RE: Revised Two Rivers Slope Analysis
Technical Adequacy Review
DRMS Letter Date June 1, 2022

TECHNICAL ADEQUACY REVIEW LETTER

Date: June 1, 2022
To: Rob Zuber
CC: Jason Musick, Michael Cunningham
From: Zach Trujillo
RE: Two Rivers Application, DRMS File No. M-2022-013
Technical Adequacy Review

UNITED STATES SEISMIC ZONE MAP

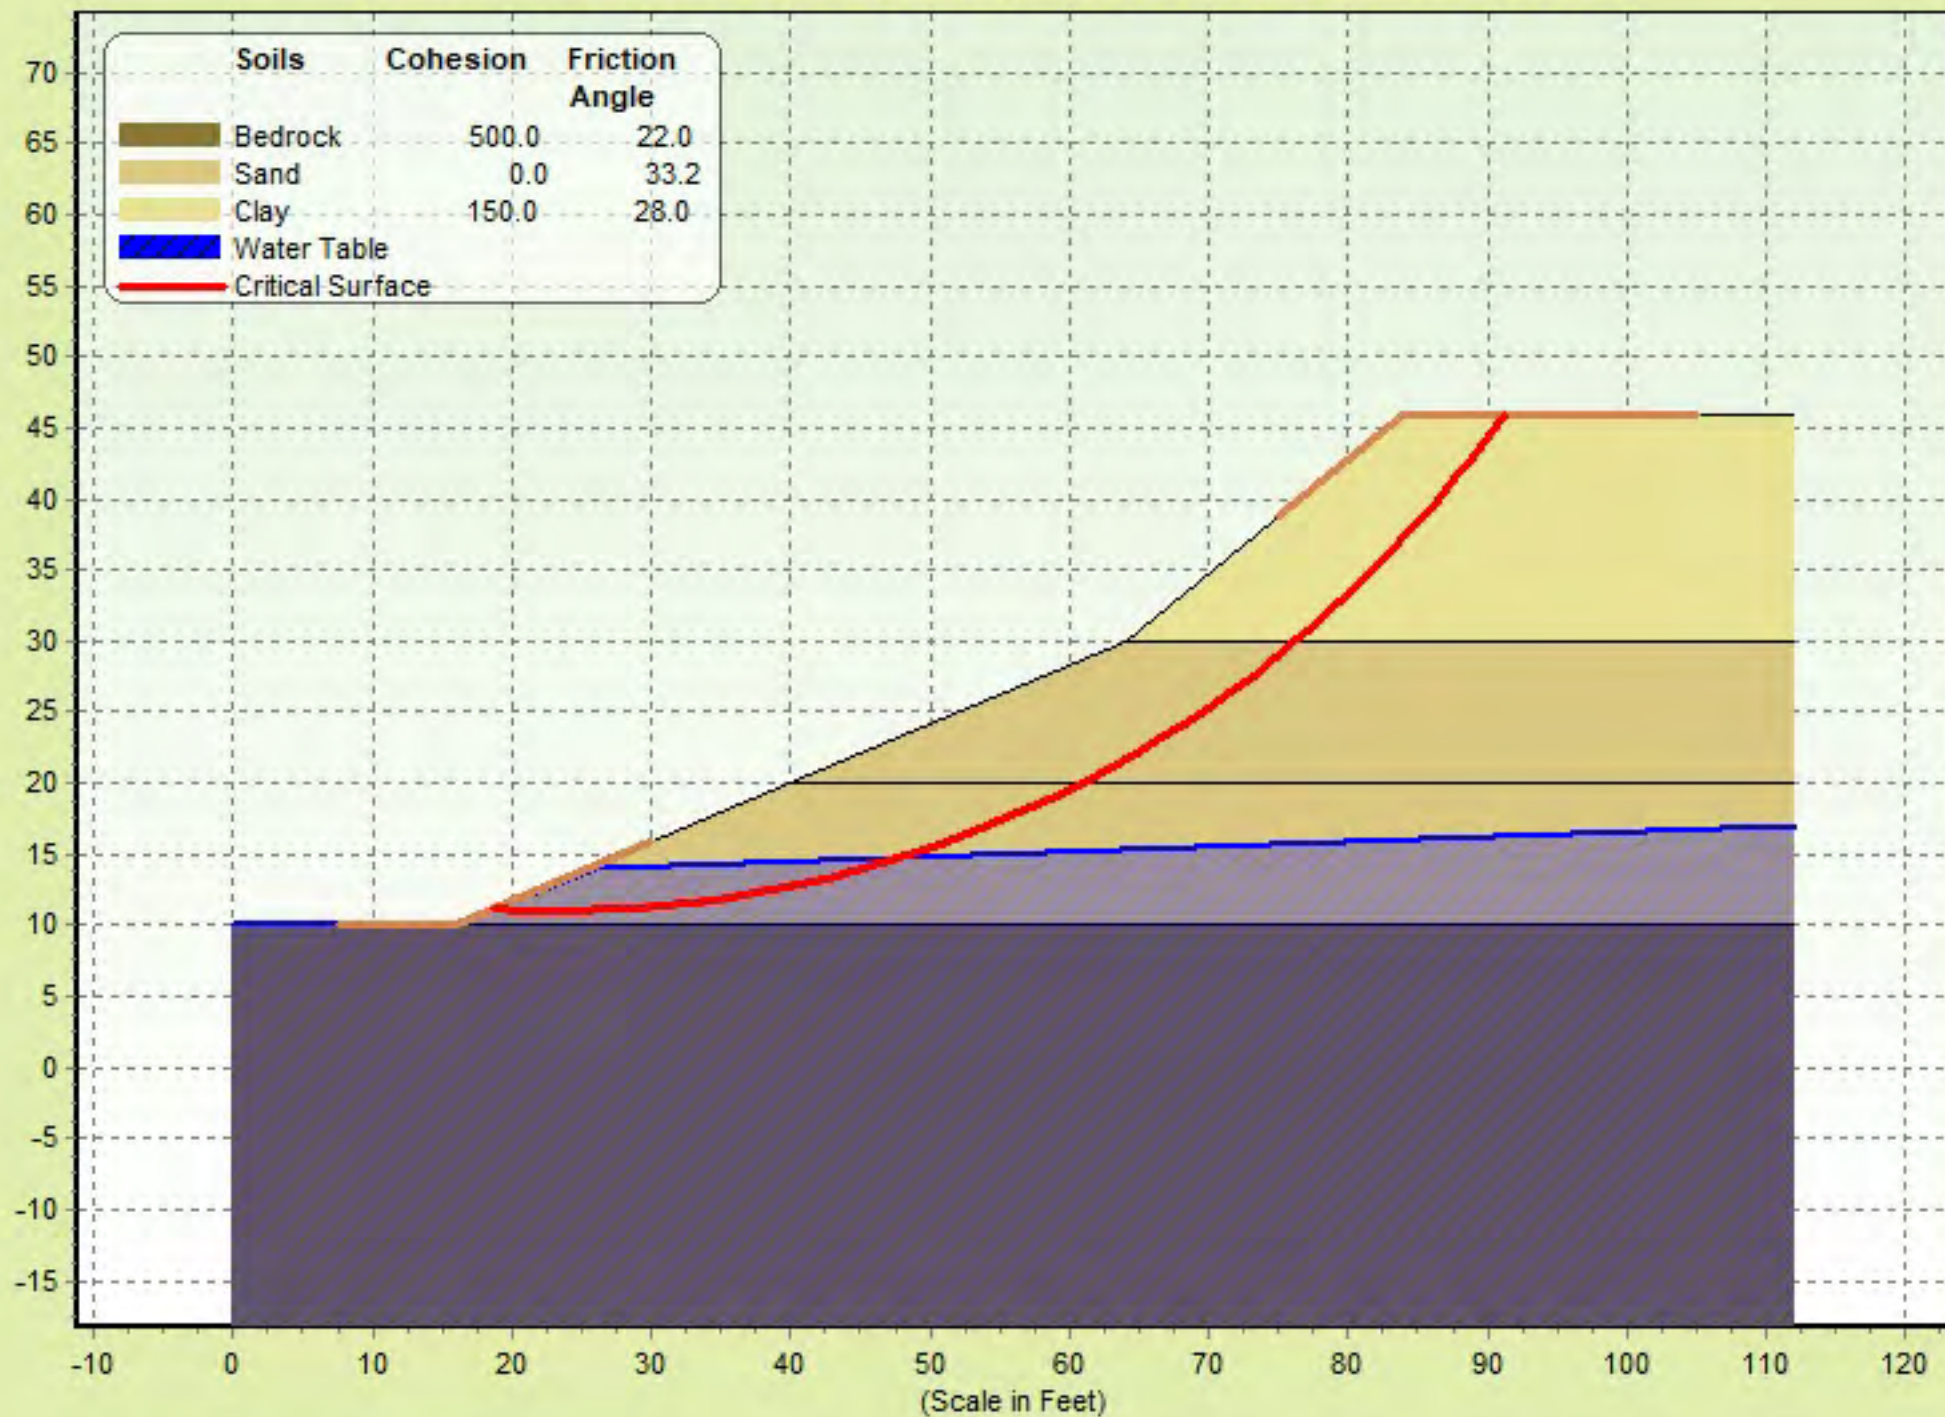
3. **Comment 3 – Please provide slope stability analyses for the four highwall scenarios under seismic conditions including rational for the seismic coefficient used in the analyses.** The four slope configurations were ran using a uniform horizontal and vertical acceleration factor of 0.075. This factor was chosen based on the United States Seismic Zone Map, which was based on the Uniform Building Code seismic values. Predicted safety factors varied between 1.15 and 1.26. Model outputs are presented in Attachment C. Included in Attachment C is the United States Seismic Zone Map.

Based on the information in the Report provided by Snake River and Table 1 of Section 30.4, FoS will be compared to strength measurements resulting from multiple tests for a critical structure. For static conditions, minimum required factor of safety is 1.3 and for seismic conditions, minimum required factor of safety is 1.15. As noted earlier under section Rule 6.5 of this memo, each resulting FoS from the four analyses indicate slope stability under static conditions. However, additional discussion will be need to be provided which will be outlined under the Comments at the end of this memo. In addition, the four scenarios provided in the Report were only analyzed on under static conditions and no models were ran or provided under seismic conditions as required under Section 30.
